Safety Recall Notice

Service Bulletin 38129

Toe Pan Panel Modification

Applicable for Toyota Lowered Floor Minivan Conversions Built 5/8/2012 to 1/4/2013

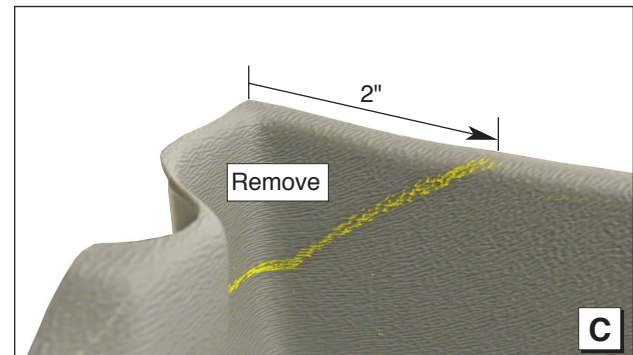
1. Remove step & roll driver seat per minivan conversion operator's manual.
2. Remove accelerator pedal. Remove two 10mm nuts and disconnect harness from pedal. See Photo A.
3. Mark area of toe pan panel to be removed. See Photos B and C.

5. Install accelerator pedal. Torque mounting nuts to 48 in/lbs each. Refer to Photo A.

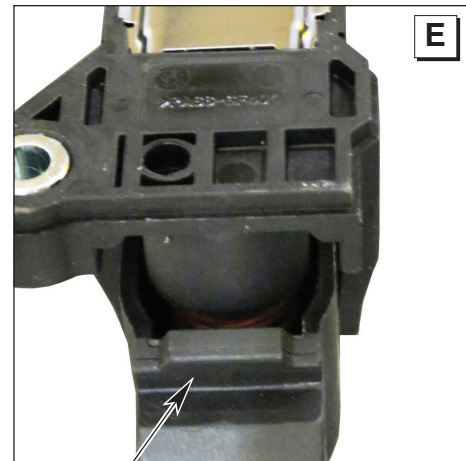
4. Remove area marked in Step 3. See result in Photo D.

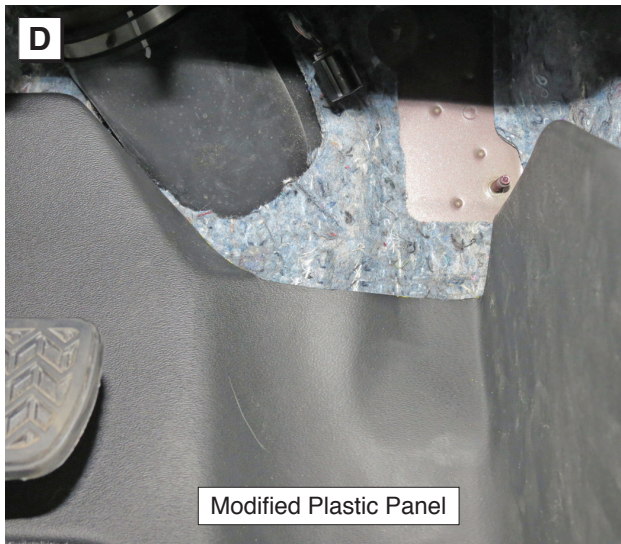
6. Operate accelerator pedal and confirm protrusion on rear of pedal will not contact the top edge of the toe pan panel. See Photos E and F.
